# Access Compliance Report

## Public Rights-of-Way

Intersection ID: 31183	Main Street: BARBEE_DR	Cross Street: FIELDSTONE_CT	Location: NE
ADA ID: 5E2A600A2896	Ramp Type: PerpDiag	Initial Pass/Fail: Fail	Overall Compliance: No
Codes/Mitigation Info/Possible Solution		Field Measurements/Component Compliance	
Severity Score: 30

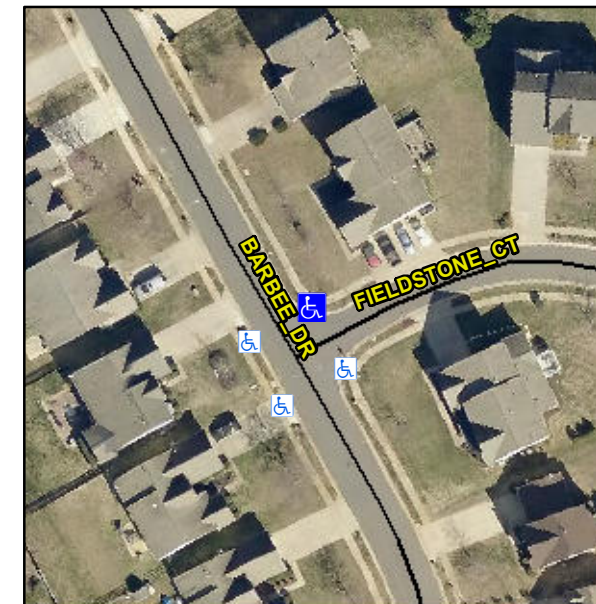
Compliance	Description	Data	Compliance	Description	Data
N/A	Ramp Length (in)	49.0	Yes	Ramp Slope (%)	5.2
No	Ramp Width (in)	33.0	No	Ramp XSlope (%)	5.1
N/A	Flare Type LT	N/A	N/A	Flare Type RT	N/A
N/A	Flare Slope LT (%)	N/A	N/A	Flare Slope RT (%)	N/A
N/A	Flare Traversable LT?	N/A	N/A	Flare Traversable RT?	N/A
N/A	Landing Length (in)	N/A	N/A	DWS Provided?	N/A
N/A	Landing Width (in)	N/A	N/A	DWS Contrast?	N/A
N/A	Landing Slope (%)	N/A	N/A	DWS Length (in)	N/A
N/A	Landing X Slope (%)	N/A	N/A	DWS Full Width?	N/A
N/A	Landing Curb? (Y/N)	N/A	N/A	DWS Offset (in)	N/A
N/A	Shared Landing?	N/A			
N/A	Gutter Ponding?	N/A	N/A	Gutter Slope (%)	N/A
N/A	Gutter Lip Ht (in)	1.5	N/A	Gutter X Slope (%)	N/A
N/A	Painted X Walk1?	No	N/A	Painted X Walk2?	No
	X Walk 1 Direction	To W		X Walk 2 Direction	To S
N/A	X Walk 1 Width (in)	N/A	N/A	X Walk 2 Width (in)	N/A
	X Walk 1 Slope (%)	4.0		X Walk 2 Slope (%)	0.2
	X Walk 1 X Slope (%)	1.1		X Walk 2 X Slope (%)	8.7

N/A	Ramp inside XWalk1?	N/A	N/A	Ramp inside XWalk2?	N/A
	Road Slope (%)	6.1	N/A	Clear Space?	N/A
	Road X Slope (%)	5.9	N/A	Clear Space to XWalk (in)	N/A
N/A	Any Obstructions?	N/A	N/A	Storm Grate/Utility Hazard?	N/A
	Obstruction Type			Storm Grate/Utility Type	
		N/A			N/A
		Yes		Surface Condition? (G/P)	Good

**Remove & Replace Curb Ramp With Two New Directional Ramps or Equivalent.**

**R304.5.1, R304.5.3**
